Product Bulletin

Product: 10266355 Preform Arm Support Upgrade

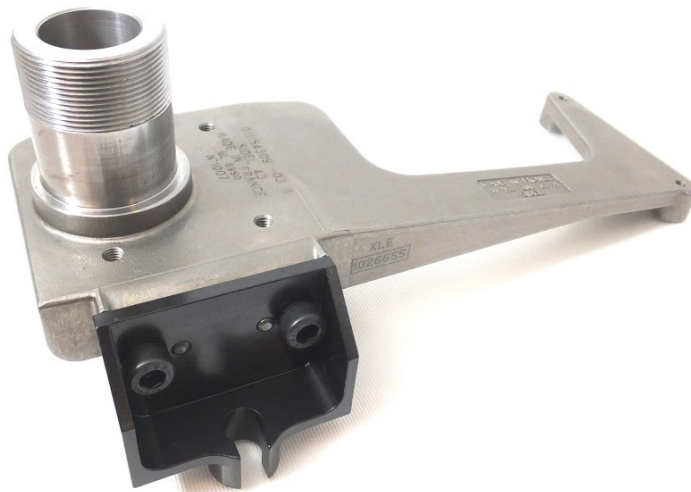
Description: When the Transfer Arm in the DC-20 machines become subjected to jams or material entering the cam track the side mount for the position track rollers will bend or twist. XL Engineering offers a solution to modify the existing support and adding a replaceable Side Mount. Although this upgrade will not prevent future damage, it does provide an economical solution. By receiving customer's damaged Supports we can machine and attach the new replaceable Side Mount in a very efficient manner. Please contact us regarding this upgrade, other upgrades, kits and all individual replacement parts for the DC-20 Transfer Arms.
